Access Compliance Report Public Rights-of-Way (Curb Ramps)

Main Street: HAZARD_AVE Cross Street: MONROE_ST Location: SE

ADA ID: RPRK220202131054 Ramp Type: Type 4 - Parallel Initial Pass/Fail: Pass Overall Compliance: No Severity Score: 6

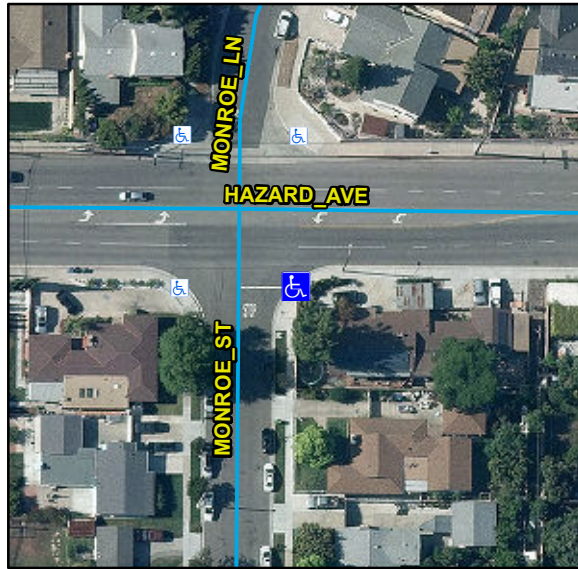
R304.5.3, R302.7, R304.5.4, STD 1115

Remove & Replace Landing. Remove & Replace Gutter.
